August 2025
Design Development Updates

Upper Brook Street Masterplan (McLaren / Kadans)

UBS-SRA-XX-XX-RP-A-00101

This document has been produced by Sheppard Robson and proposes minor changes to the approved Sci-Tech scheme located in Upper Brook Street, Manchester.

Ground Floor

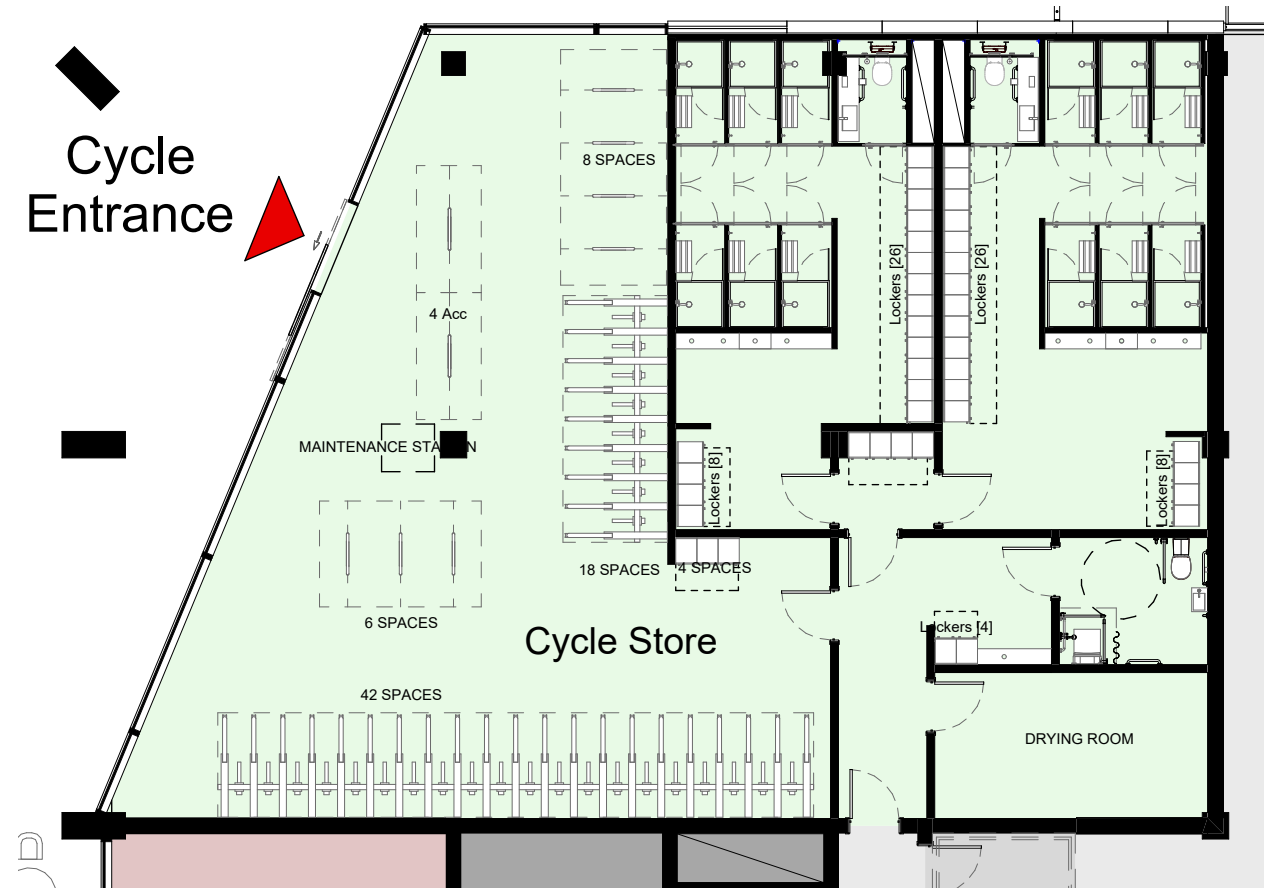
Escape door sizes have been reviewed following coordination with the fire consultant.
- L0.2

The cycle store layout and end of trip facilities were reconfigured. Locker, cycle spaces and shower numbers have been updated.
- L0.3

The back of house facade was updated following IDNO coordination (introduction of their compliant doors).
- L0.4

Minimum amendments to the cafe area to allow for a more flexible tenant fit-out. This includes rationalisation of the screens to the atrium and splitting of external glazing closest to the cycle store into in three panels instead of two.
- L0.5

Change Code	Drawings Affected	Description	Design Development Justification
L0.1	- UBS-SRA-ZZ-EE-DR-A-02-308 - UBS-SRA-ZZ-ES-DR-A-02-307 - UBS SRA ZZ EN DR A 02-306 - UBS-SRA-ST-00-DR-A-02-500 - UBS-SRA-ZZ-00-DR-A-02-100*	Fire Escape double doors sizes were updated	Door dimensions have been reviewed following coordination with the design team and specialists regarding width of escape route corridors and minimum widths of escape doors
L0.2	- UBS-SRA-ST-00-DR-A-02-500 - UBS-SRA-ZZ-00-DR-A-02-100*	Cycle Store layout reconfigured	Cycle store layout rearranged following design development and coordination in changing room areas (for improved MEP service routes) and ACC changing room. Updates to external cycle parking arrangements to incorporate WELL requirements.
L0.3	- UBS-SRA-ST-00-DR-A-02-500 - UBS-SRA-ZZ-00-DR-A-02-100* - UBS-SRA-ZZ-EE-DR-A-02-308	Back of house doors updated	Substation doors confirmed following coordination with IDNO

L0.4	- UBS-SRA-ST-00-DR-A-02-500 - UBS-SRA-ZZ-00-DR-A-02-100* - UBS-SRA-ZZ-EW-DR-A-02-311	Rationalisation of the screens to the atrium; external curtain wall glazing to Thorburn walk have been split into three panels instead of two.	The changes were made to allow for a more flexible fit out by the future tenant, including WC and Kitchen position. The screens were developed to allow for a connection between the cafe area and the atrium for events.
L0.5	None	Entrance soffit material defined as anodised aluminium	Following a series of design studies, anodised aluminium to match the perimeter cladding of the soffit provided the most solid and inviting entrance.

Cycle Store Layout

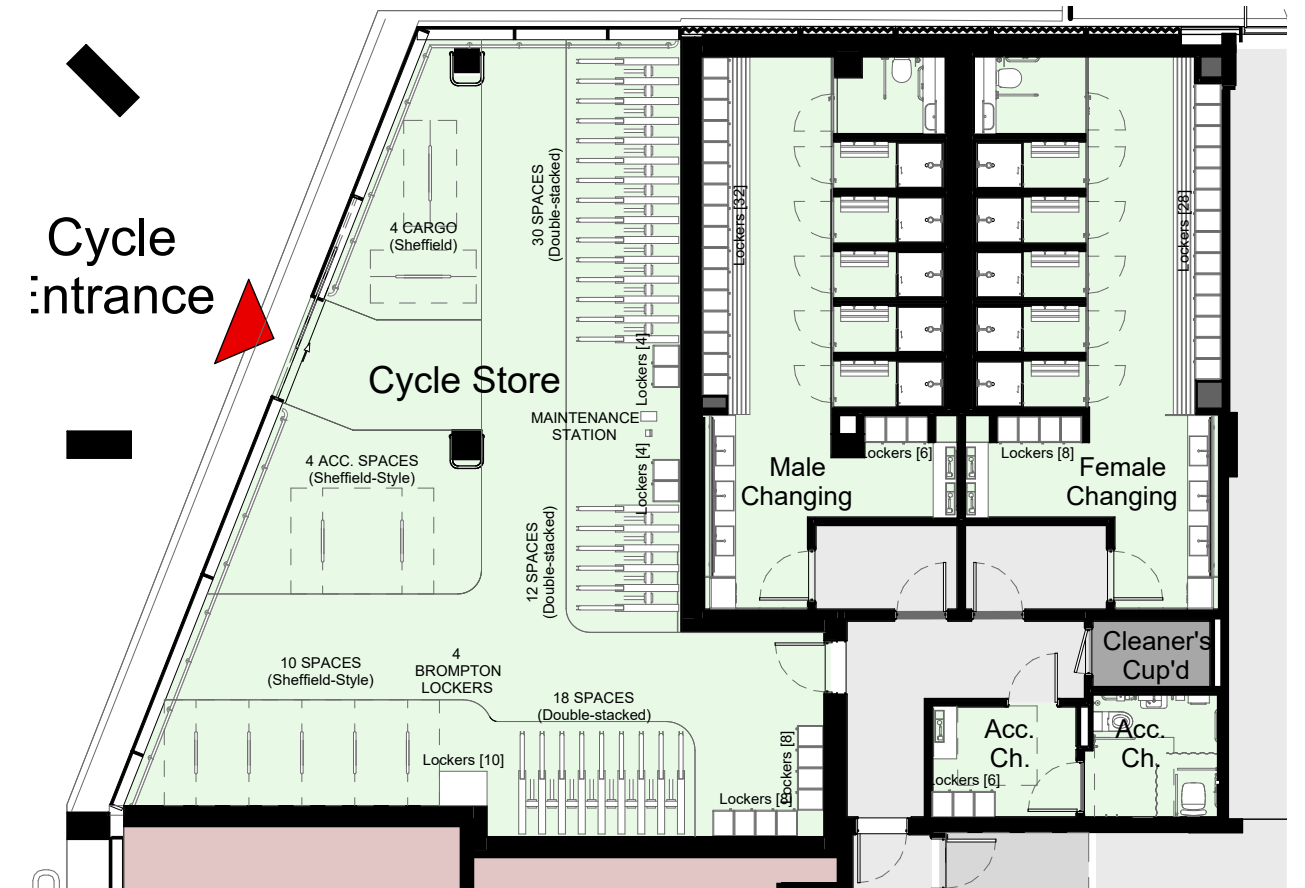
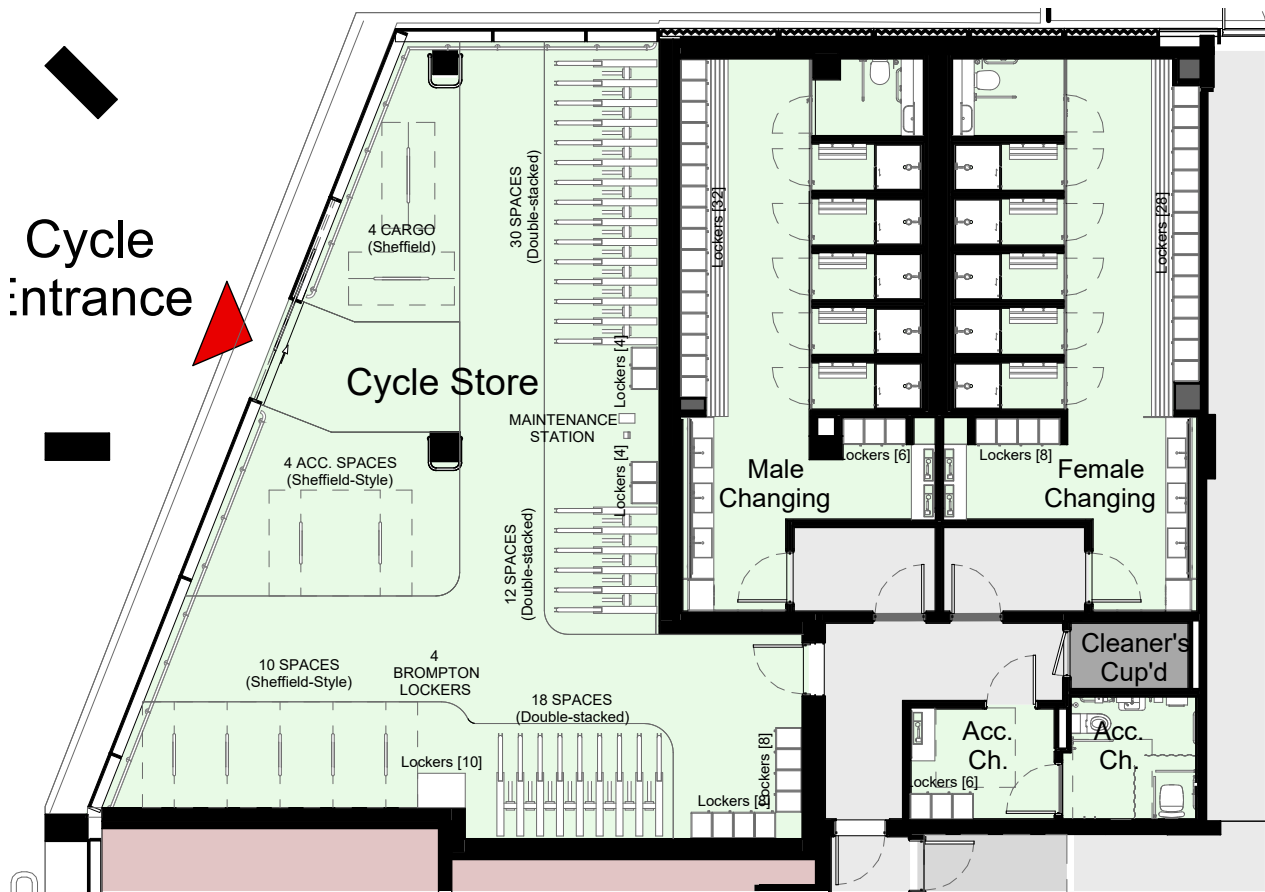
10x External Cycle Spaces added
(future provision) to incorporate
WELL requirements

The Cycle Store layout and numbers have been calculated to comply with policy (MLDF 2012), which is more onerous than WELL and BREEAM. The number of lockers has been calculated with BCO ratios/BREEAM and the number of showers is compliant with BS 6465.

Back Of House Facade updates

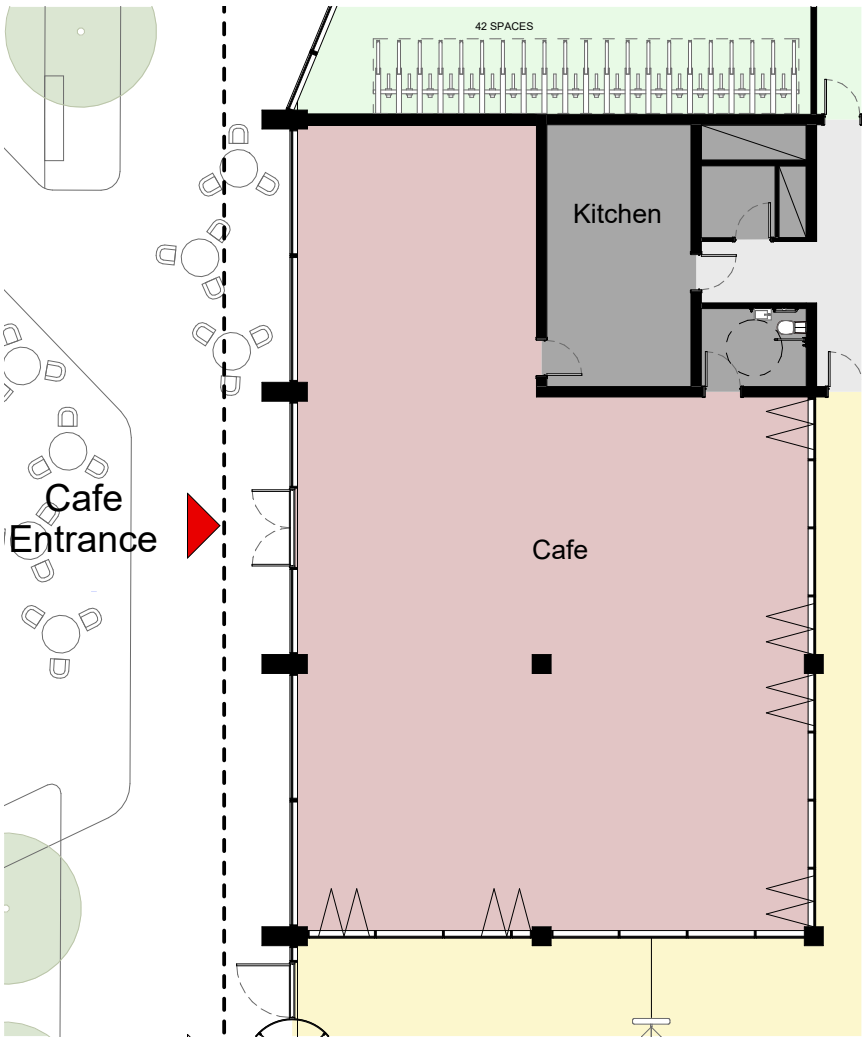
L0.3 The back of house facade was updated following IDNO coordination (introduction of their compliant doors).

A Escape door sizes have been reviewed following coordination with the fire consultant.

B The back of house facade was updated following IDNO coordination (introduction of their compliant double bi-folded doors)

Ground Floor Cafe Layout

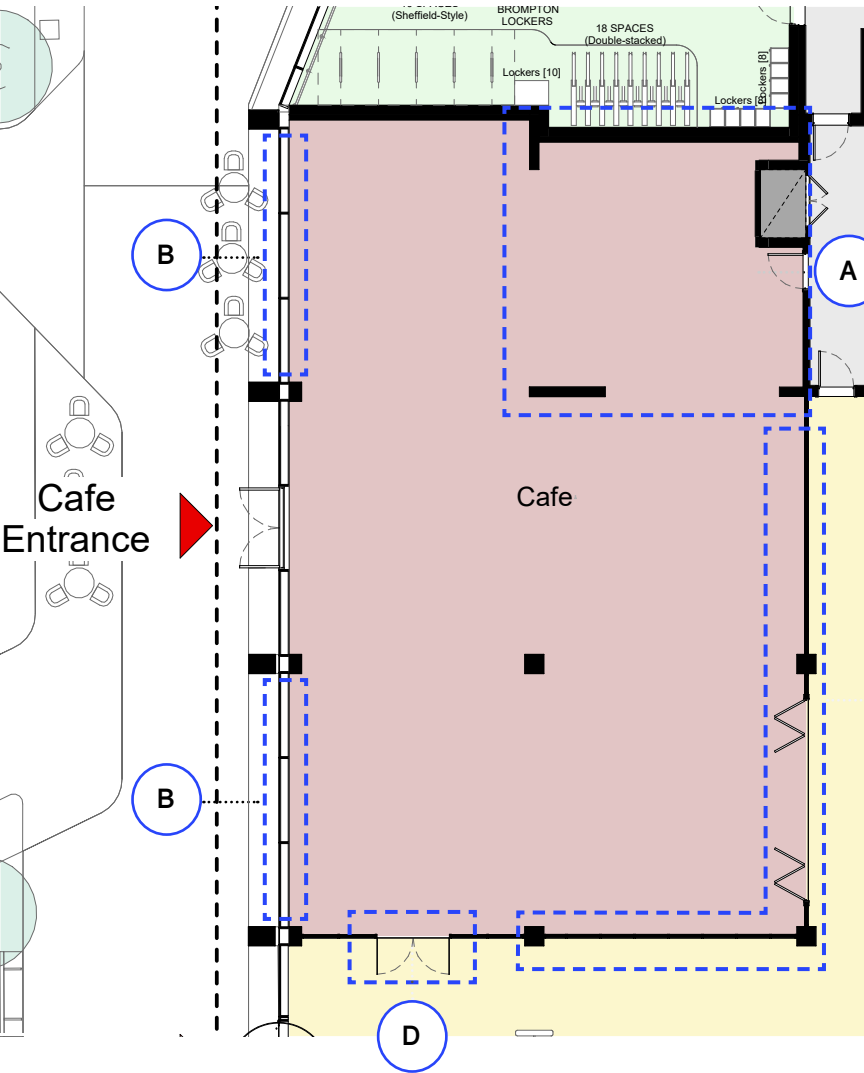
- L0.4** Minimum amendments to the cafe area to allow for a more flexible tenant fit-out. This includes rationalisation of the screens to the atrium and splitting of external glazing closest to the cycle store into in three panels instead of two.
- A** Removal of the Cafe back of house area (kitchen and store rooms) to allow flexibility for the future tenant fit-out
- B** Facade mullions to Thorburn Walk at GF and Level 01 level has increased from 2 to 3 per bay
- C** Cafe interface with atrium interior has been optimised
- D** Introduction of an alternative door to comply with fire strategy requirements
